APPLICATION NO.	FILING DATE	FIRST NAMED INVENTOR	ATTORNEY DOCKET NO.	CONFIRMATION NO.
10/083,751	02/25/2002	Yoshihisa Kamiya	44471/270726	2302

Office Action Summary

DETAILED ACTION

Fig. 6

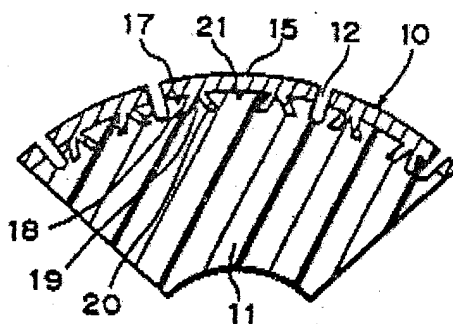
Kanno et al. discloses in Figure #6 a plurality of commutator segments (10) that are arranged externally on the cylindrical surface of the commutator with insulating resin portion (11) having anchors (claws) (20) are fixed to the commutator segments (10); with undercuts (12) formed on the molded resin (conductive material) (11). Figure #8 further discloses anchors (internal claws, that act as anchors) (20A and 20B), extend the length of the commutator segments (10). Furthermore, in Figure #8 a groove (19A-B) are formed on an inner surface and the anchors (20A-B) projecting from the inner surface. Additionally, Kanno et al. discloses in Figure #15 a the grooves (17) and the anchors (20) being extended from a second end of the commutator segment to the end of the first end, in which an end step and an end edge are end at the first end.

Fig. 15

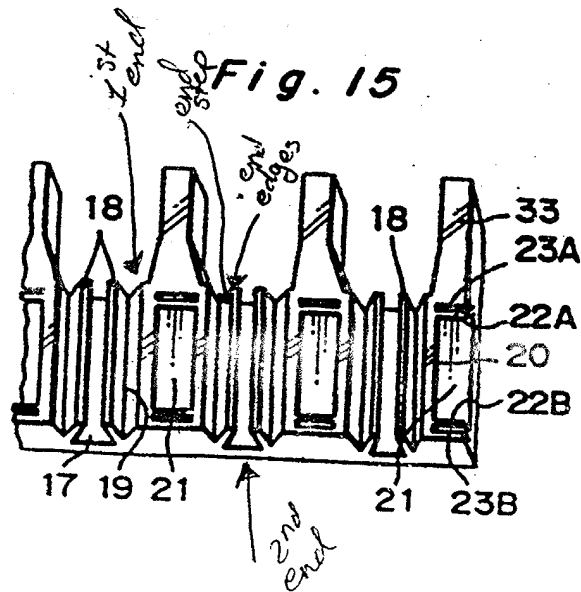
In regards to applicant's argument that Kanno et al. does not recite the amendment of Claim 5, the examiner respectfully disagrees. As stated above in the 102 reject of Claim 5 Kanno et al. discloses in Figure 15 the limitations of "the groove and the anchors being extended from a second end of the segment opposite to the first end and being ended close to the first end by an end step and end edges." Applicant does not disclose what the end edges and end steps are in the drawings or the specification and thus the examiner understands that the end edges and end steps are the ends of the anchors as understood from the wording of the claims. It is advised that the applicant amend the specification and drawings if the examiner is incorrect.

FIG. 2

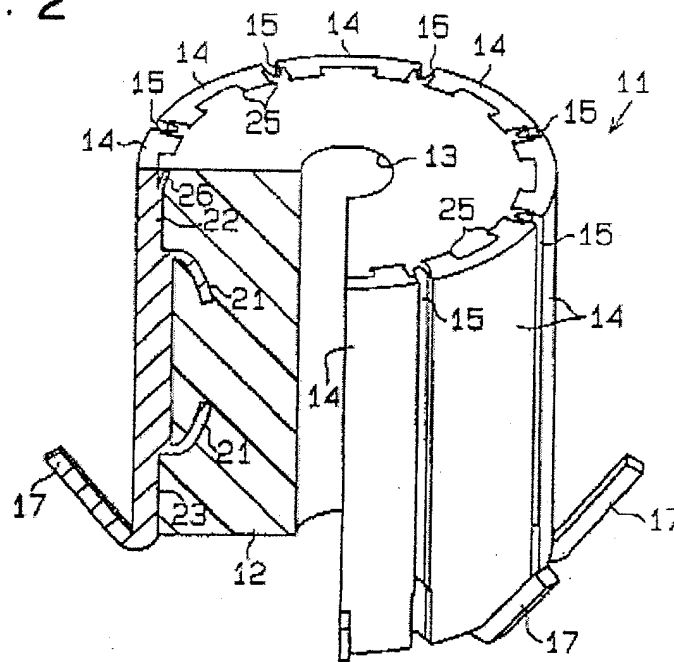
Kageyama et al. illustrates in Figure # 2 hooks (claw) (17) having an inner hooks (anchors-inner claws) (21) bent inwardly and that the anchors is from a proximal end of the hooks which are embedded into the insulation body (12), for the purpose of holding of insulation body at the central portion of the commutator segments.

In regards to applicants argument of Claim 3 Kageyama et al. illustrates in Figure 2 that the second anchors are divided from into two hooks and the internal side of the hook is bent inward as stated in the limitation of the claim. Kageyama does disclose in figure 2 the second anchors projecting inward from a proximal end of the hooks. Kanno et al. discloses in the prior art figures 2-3 second anchors (5A and 5B) that are projecting inwardly from proximal ends of the hook (claw)(A), thus the structural combination of the second anchors and the anchors and the hooks would be obvious to one of ordinary skill in the art.

Fig. 2 (Prior Art)

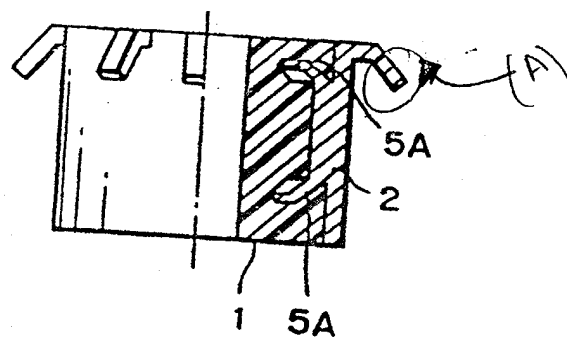
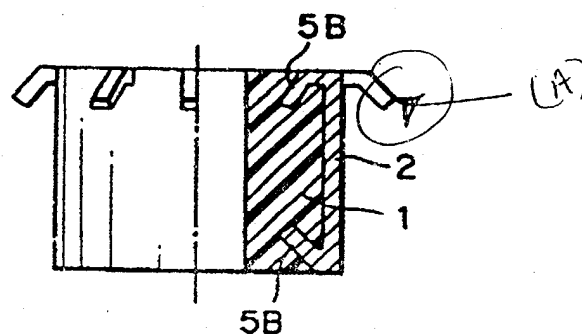
Claim 5 is rejected under 35 U.S.C. 112, first paragraph, as containing subject matter which was not described in the specification in such a way as to reasonably convey to one skilled in the relevant art that the inventors, at the time the application was filed, had possession of the claimed invention. The "first end, second end, end step and end edges" are assumed by the examiner to be located below as indicated by

what the examiner perceive to be the "first end, second end, end edges, and end step".

It is advised by the examiner for the applicant to correct the drawings to show the claimed subject matter and to modify the specification to reflect the claimed subject matter.
